Sheirdrim Renewable Energy Development

Additional Information - Appendices

**Clarification Correspondence provided to
consultees**

SHEIDRIM RENEWABLE ENERGY DEVELOPMENT - PEAT LANDSLIDE HAZARD AND RISK ASSESSMENT RESPONSE TO STAGE 1 CHECKING REPORT, FEBRUARY 2020

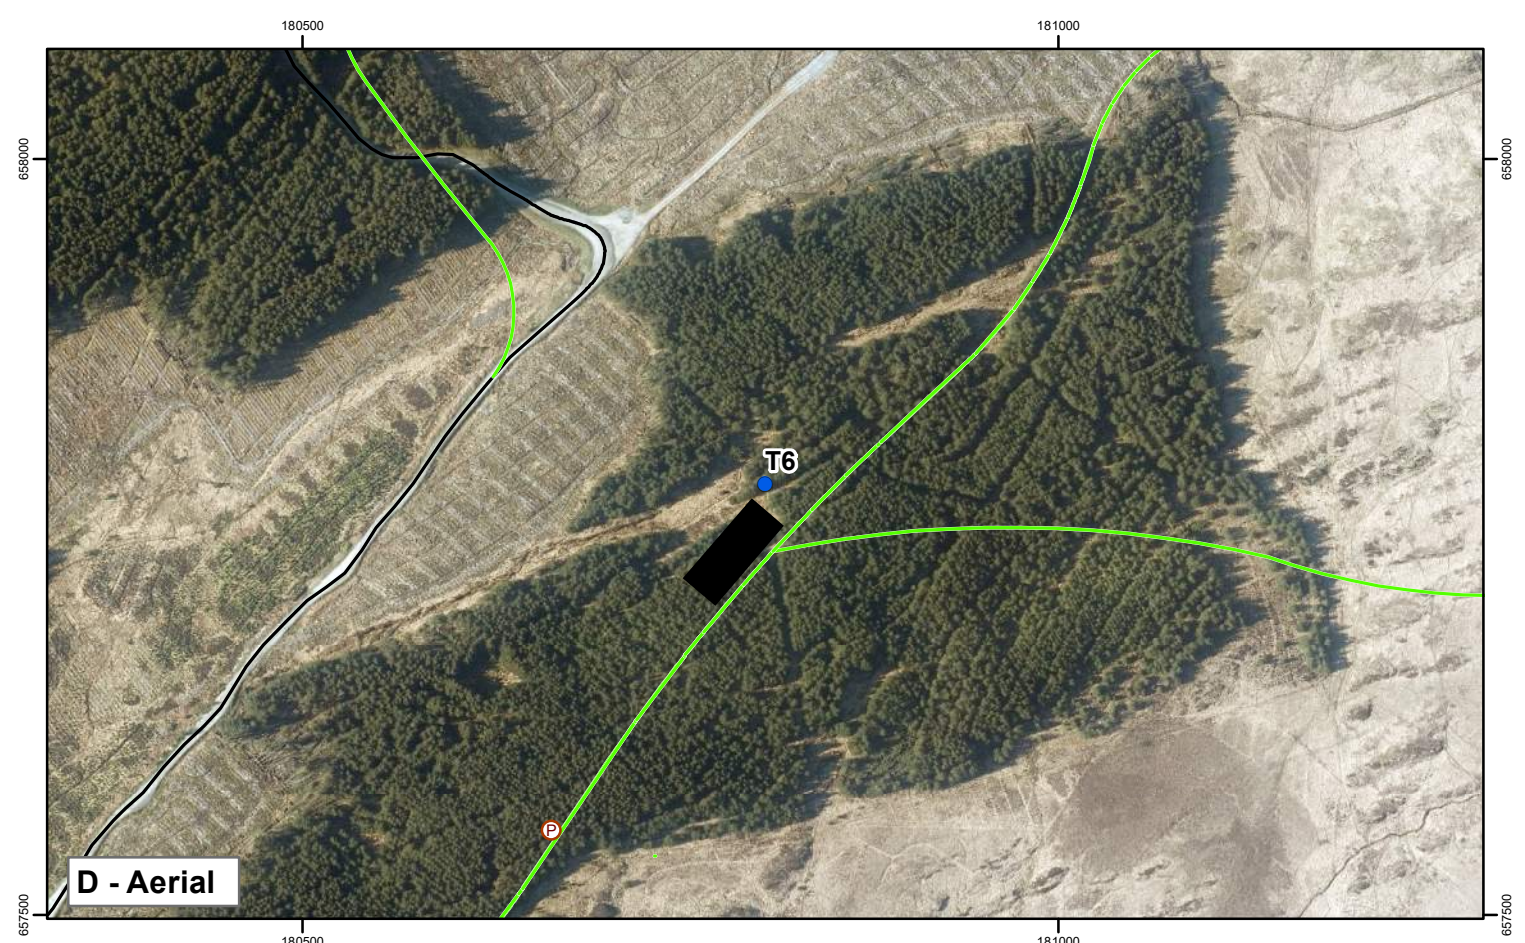
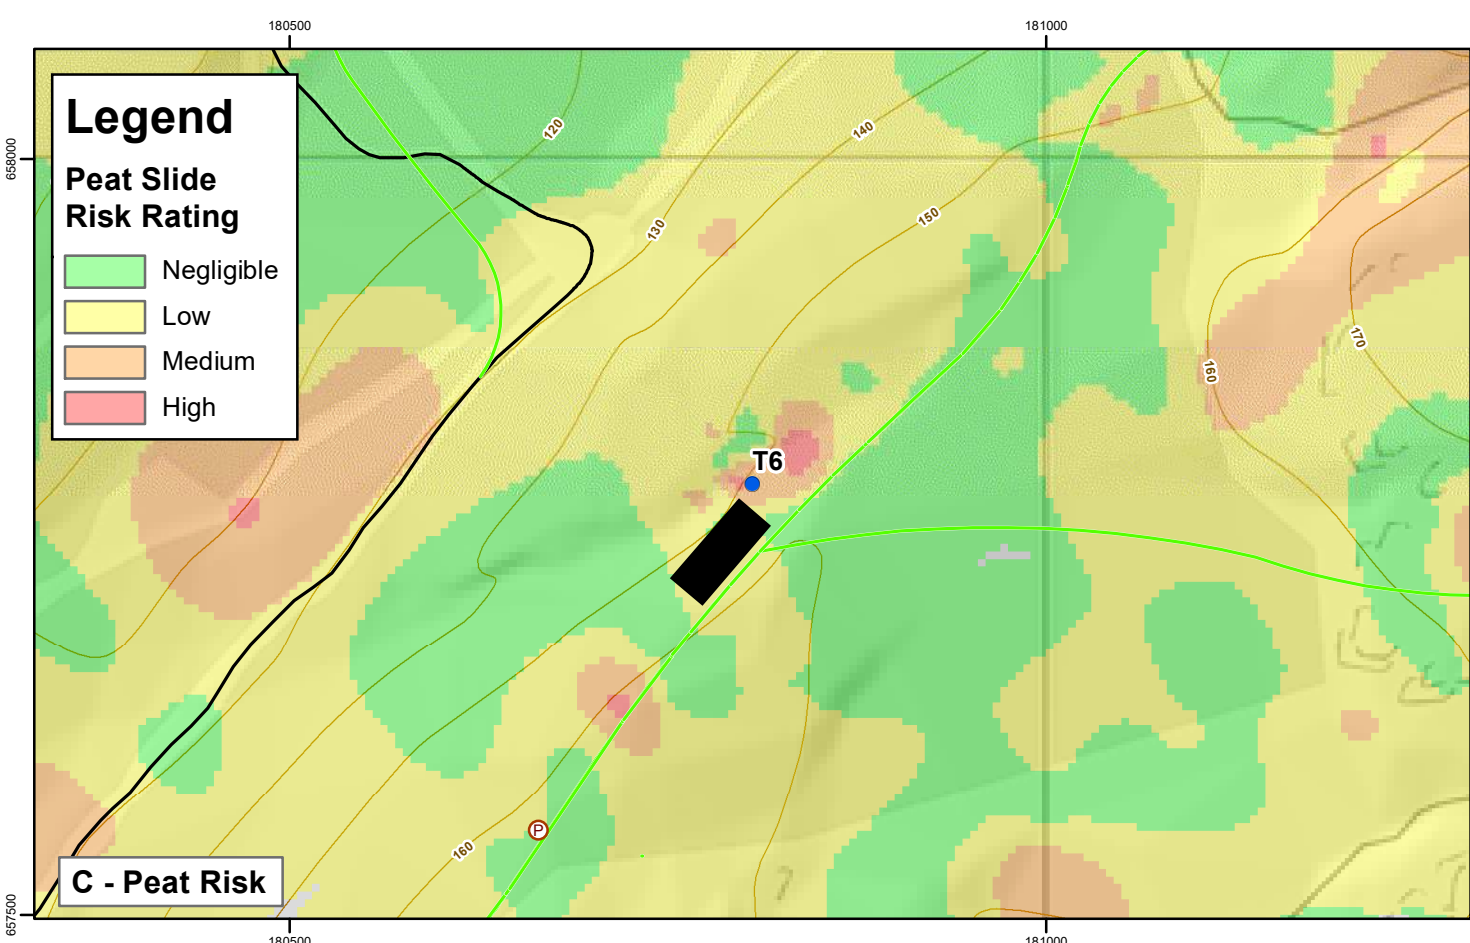
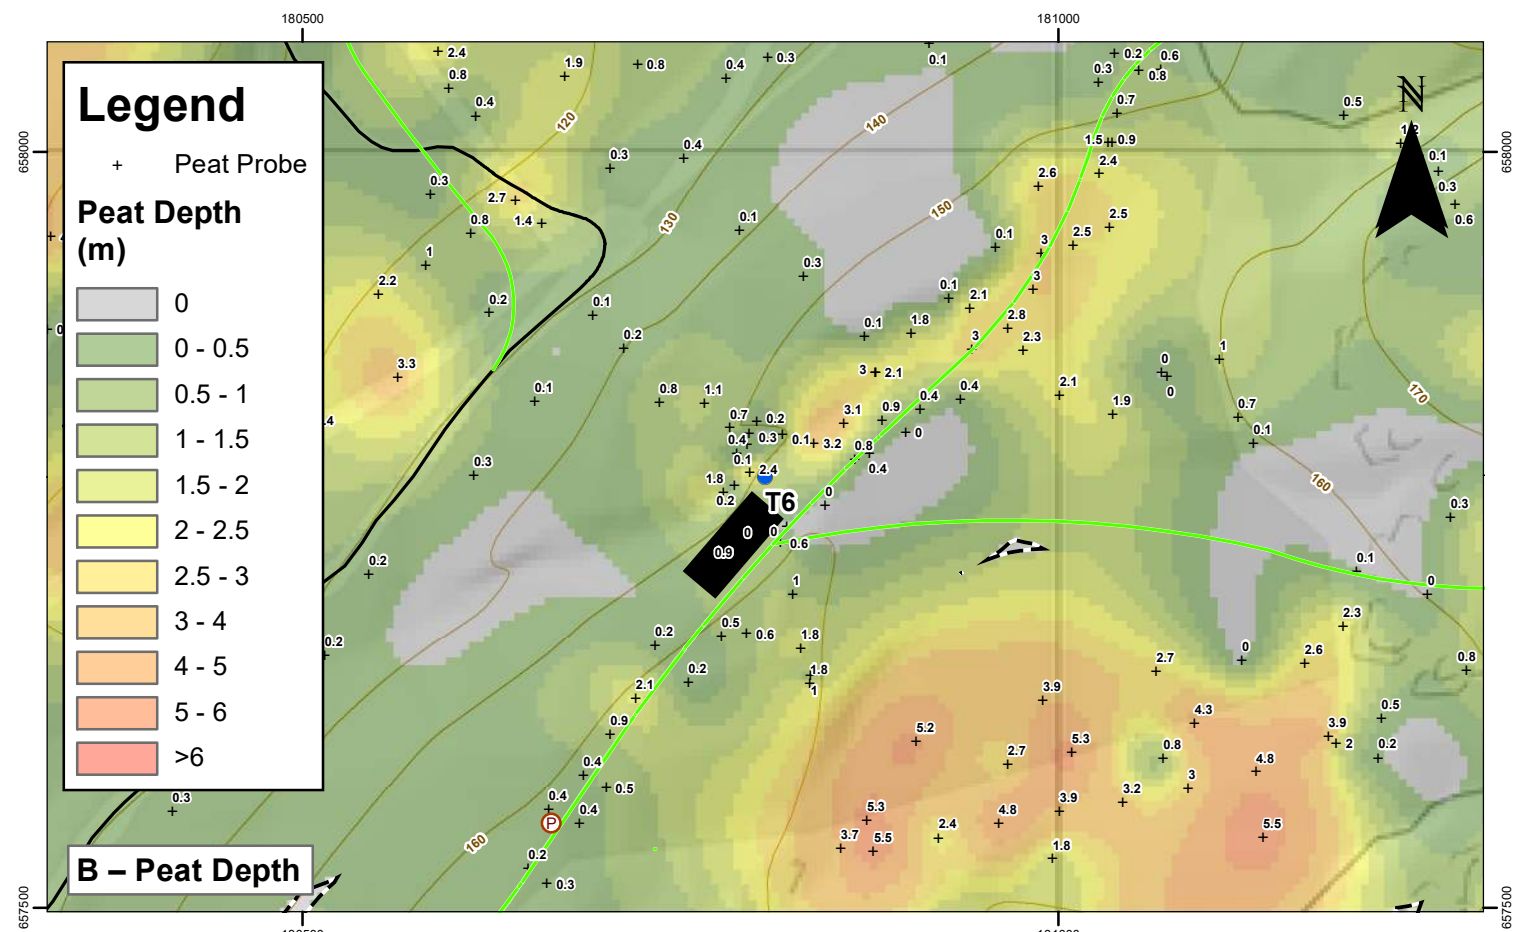
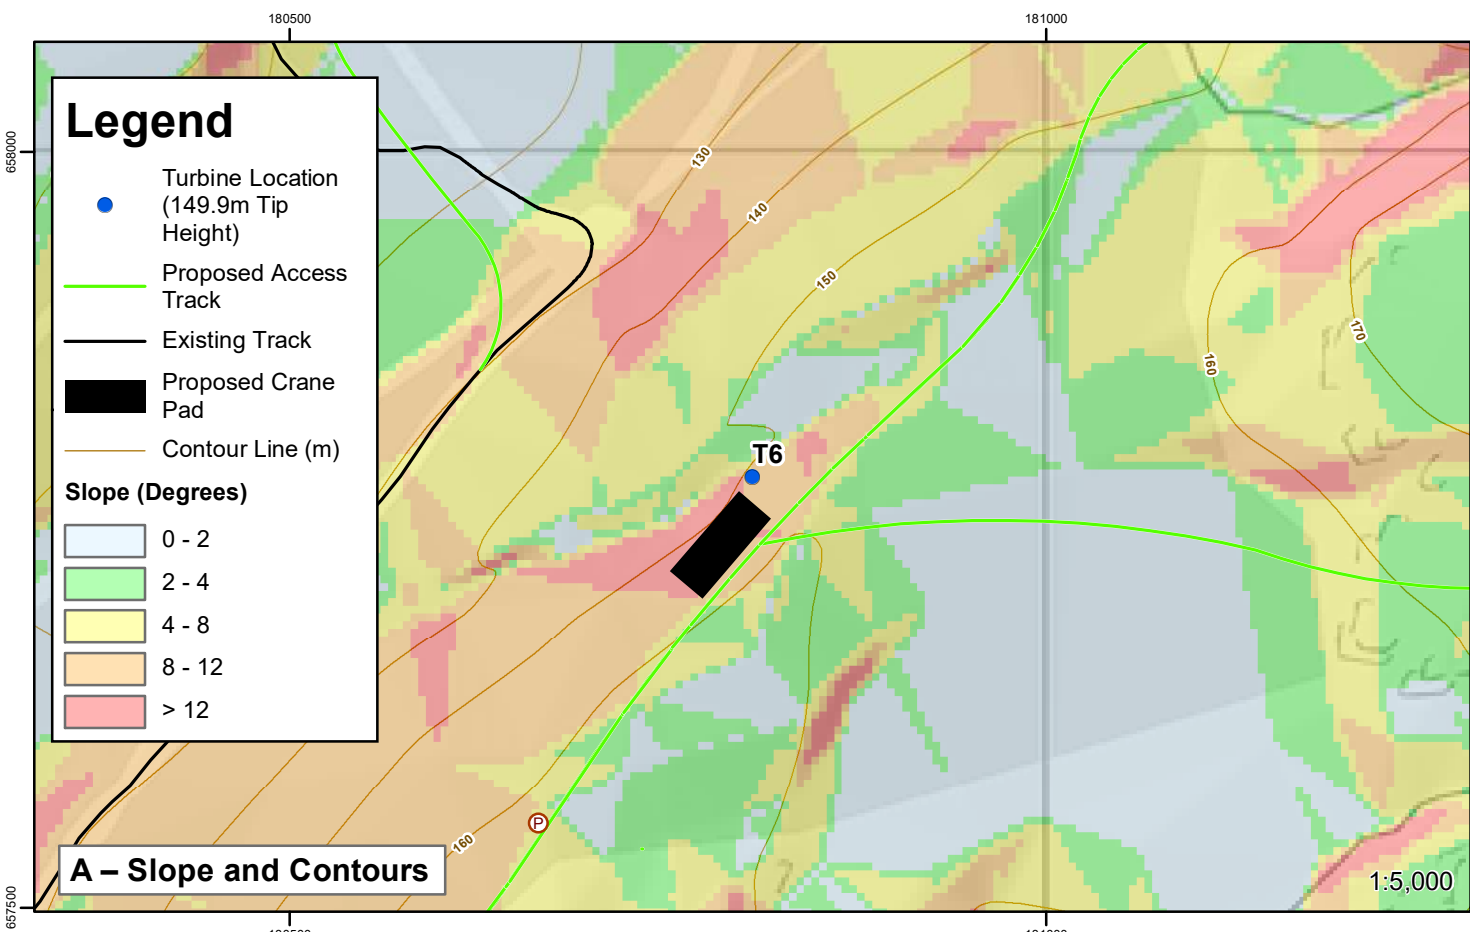
One point remains that requires discussion. It is noted that it is proposed to excavate the slope surrounding Turbine 6 in order to mitigate a high risk zone. IFL are unclear on how large an excavation is required, i.e. is it a small slope within the area of turbine base or a large area of slope above the turbine. Would it be possible to provide an area specific plan showing the extent of the excavation as requested of the Stage 3 checking report?

The area falls to the north west quite steeply so the plan was to cut a small bench for the crane pad and turbine. There are a couple of very localised peat depths which skew the analysis. It may be possible to microsite the turbine towards the crane hardstanding but as you see one value of 2.4m at the turbine is the issue, combined with the steeper slope, it is very localised. In fact this would actually be excavated out as part of the excavation and all around it are shallow peat values. The excavation would be very limited and probably not much larger than the crane pad area. A diagram showing the area of concern is attached, I am confident this will meet your requirements.

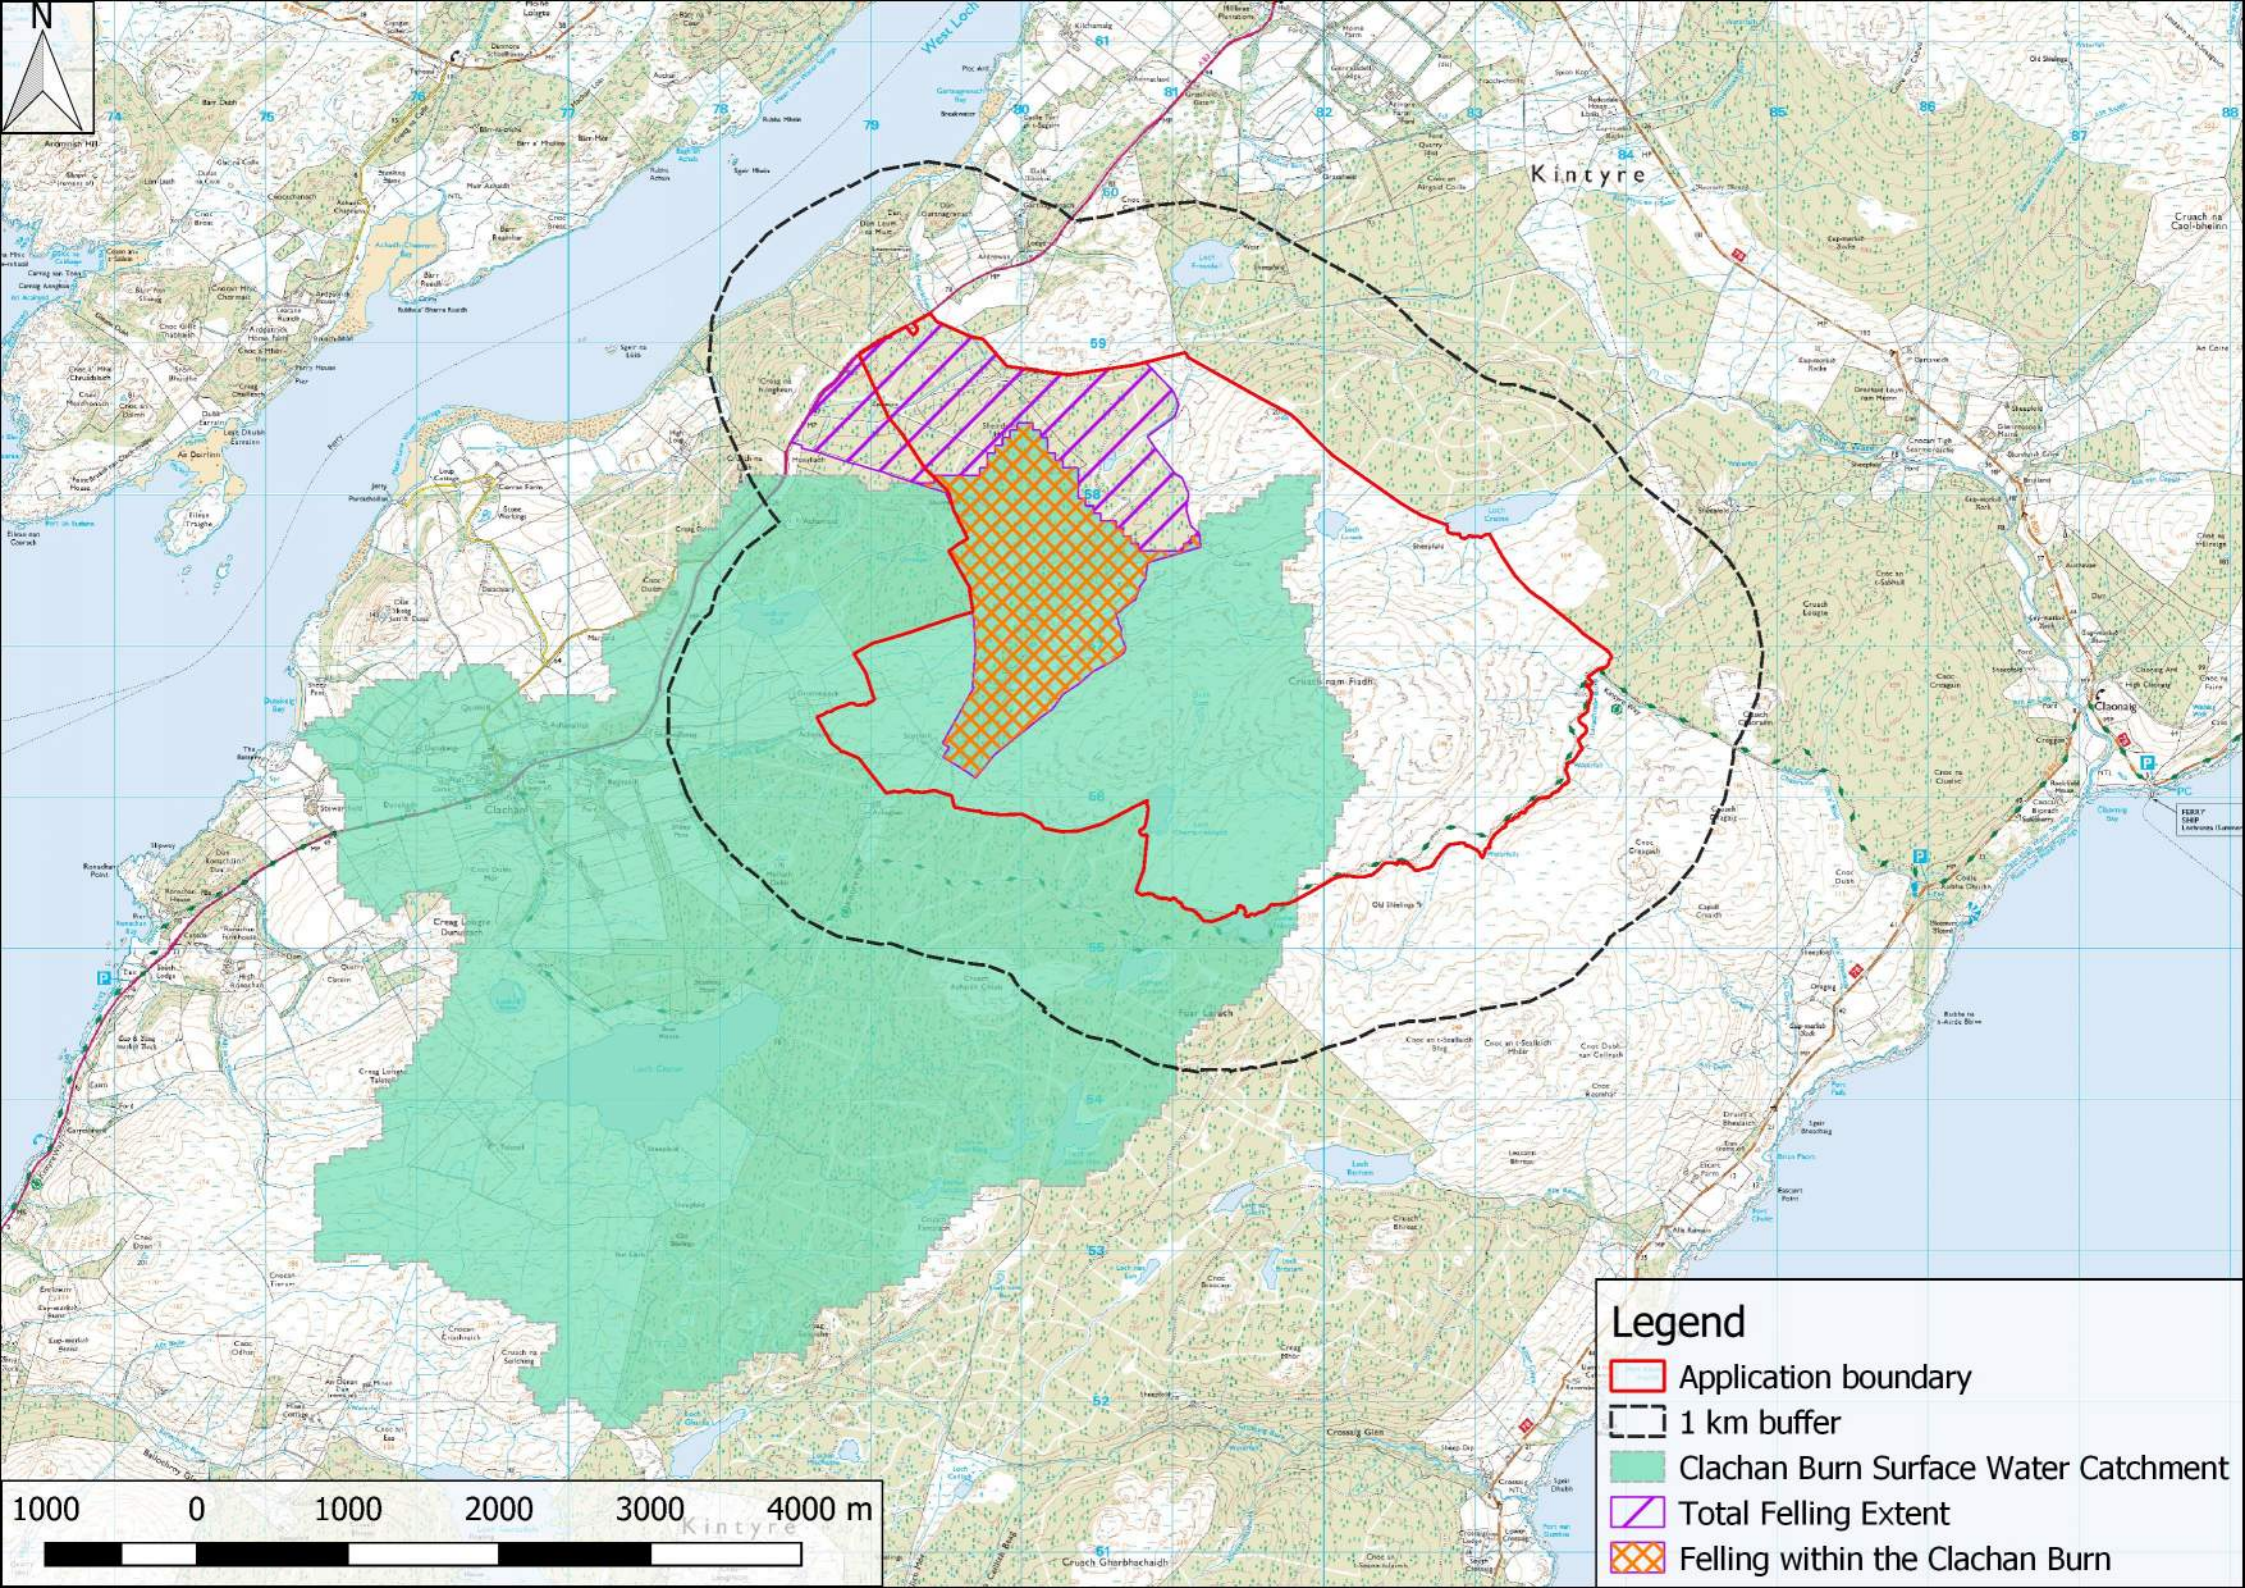
- **A catchment scale calculation is needed to demonstrate that the increased felling proposed will not have a negative impact on the flooding issue. If an effect is found then, comment is also required on synchronisation issues with the Allt Mohr Burn. A new forest plan is being prepared for the neighbouring woodland at Achavhraid.**

- *It is also recognised that additional forest felling, in accordance with the wider forest felling, will occur within 10-years of construction of the proposed Development. The attached plan shows the Clachan Burn surface water catchment and the total potential felling extent (not just felling resulting from the proposed Development). As a worst case, as all the felling would not occur within 10-years, the total area of felling is 3.8 km², of which 1.8 km² is within the catchment of the Clachan Burn. Thus, the proportion of potential felling is only 6.3% of the Clachan Burn catchment and forest felling, which is significantly less than the >20% figure stated by Scottish Forestry. Therefore, the total felling in the Clachan catchment is unlikely to have any significant adverse effect on flooding occurrence at Clachan.*
